Review of the Shell/Exxon Brent
Decommissioning Derogation
Assessment and of the corresponding
proposal by UK BEIS

Report Prepared by
Scientia et Sagacitas Ltd.
Aberdeen
United Kingdom

May 2019

Figure 4 Brent Alpha Derogated Footings Proposal (from Shell Brent Alpha Jacket Technical Document BDE-A-JKT-BA-5801-00001 Page 39)

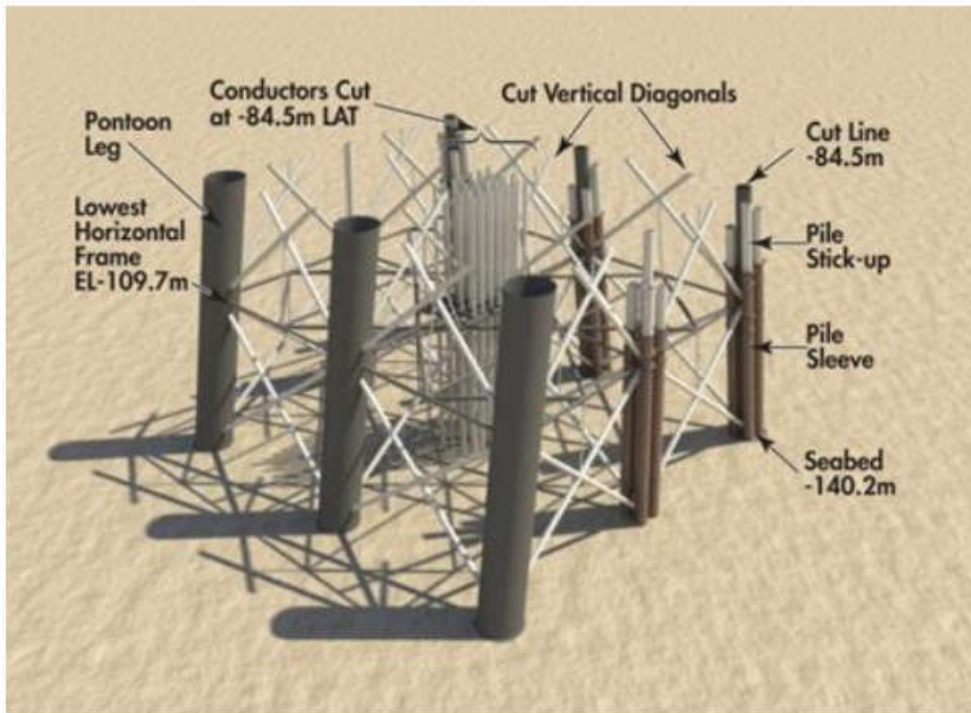
- Shell/Exxon indicate that the Brent Alpha Jacket Footings could be removed at an estimated cost of £60 million. However, the derogation recommendation is clearly supported using the biased CA process.

- Drill cuttings around the footings would be disturbed if the footings were removed – but the level of disturbance could be minimised by use of internal leg cuttings tools, that would need development.

- Shell/Exxon have not unambiguously discounted the technical feasibility of footings removal
- Recent statements by BEIS at the Decommissioning Conference, St Andrews, Nov 2017 (see <https://www.energyvoice.com/oilandgas/decom/157503/decom-conference-ospar-decommissioning-rules-right-place-oguk-says/>) appear to indicate a policy of relaxation of the method of calculating ‘jacket weights’, potentially increasing the number of steel jacket derogation applications in the UKCS from 33 to 50. This re-interpretation of the OSPAR Decision 98/3 is contrary to the spirit and intent of OSPAR objectives and should be challenged.

- Some 20 years after the OSPAR Decision 98/3 the drive to develop technology for footings removal still does not appear to have evolved, which is of concern. The above ‘relaxation’ by BEIS will further erode the oilfield service sector’s business case for developing tools to make jacket footings removal a more attractive proposition. This lack of incentive to deliver the OSPAR Decision 98/3 objectives by BEIS and the Industry should be challenged, with consideration being given to the introduction of a US Government Bureau of Safety and Environmental Enforcement style ‘Idle Iron’ (see Appendix A) type of time limit (e.g. no more jacket derogation approvals post 2025, and an expectation for currently derogated jacket footings to be removed by 2030)

- BEIS to provide more clarity on how they intend to advance the development of the necessary tooling to effect full removal of lower jacket sections – thus reducing derogation applications as expected by OSPAR.
- Continued assessment of advancing cutting technologies within both the energy and salvage sectors

Figure 5 CGBS Storage Cell Diagram (from Shell Brent GBS Contents Technical Document BDE-F-GBS-BA-5801-00002 Page 28)

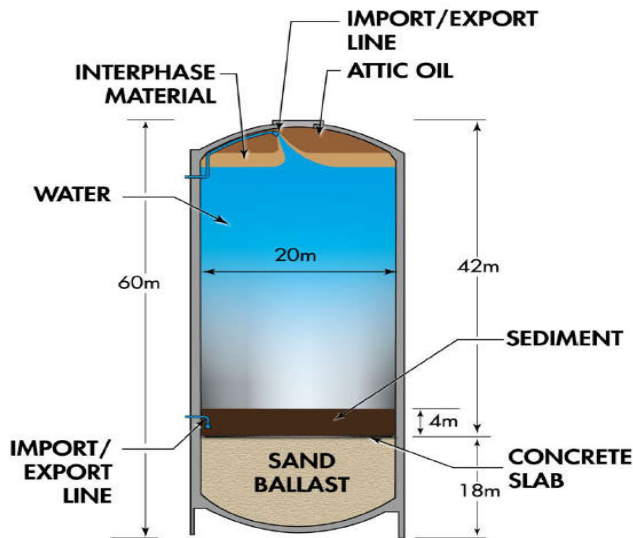
- There appears to be confusion with respect to the waste classification of the CGBS storage cell inventories, with indications that at least 3 differing sets of Regulations (OSPAR Decision 98/3, London Protocol and Offshore Oil & Gas production operations discharge regulations) appear to have been 'selectively' applied to the Attic oil/Interphase materials, water and sediment inventories (which are shown in the diagram below). The issue of CGBS storage cell contents classification is an area that requires urgent clarification.

- The application of the CA process to CGBS Storage, Tri and Mini Cell contents is not clearly justified and appears to be based upon separate discussions with BEIS. It is not clear that the OSPAR Decision 98/3 can be applied to them under the ‘other substances contained within them’ phrase from the OSPAR Decision 98/3 (Annexe 2 3a)), nor that the CA process used is appropriate for the issue under consideration. This approach requires discussion, clarification and agreement within the OSPAR Commission before it can be accepted as appropriate.

- The adoption of ‘conceptual’ cell contents removal studies means that there are significant ranges in estimated values (safety, technical feasibility, costs, schedules etc.) that should have been incorporated into their Comparative Assessment (CA) Process evaluations as uncertainty bands, but they have not been. This is a failure to comply with OSPAR Decision 98/3, Annex 2, requirement 10
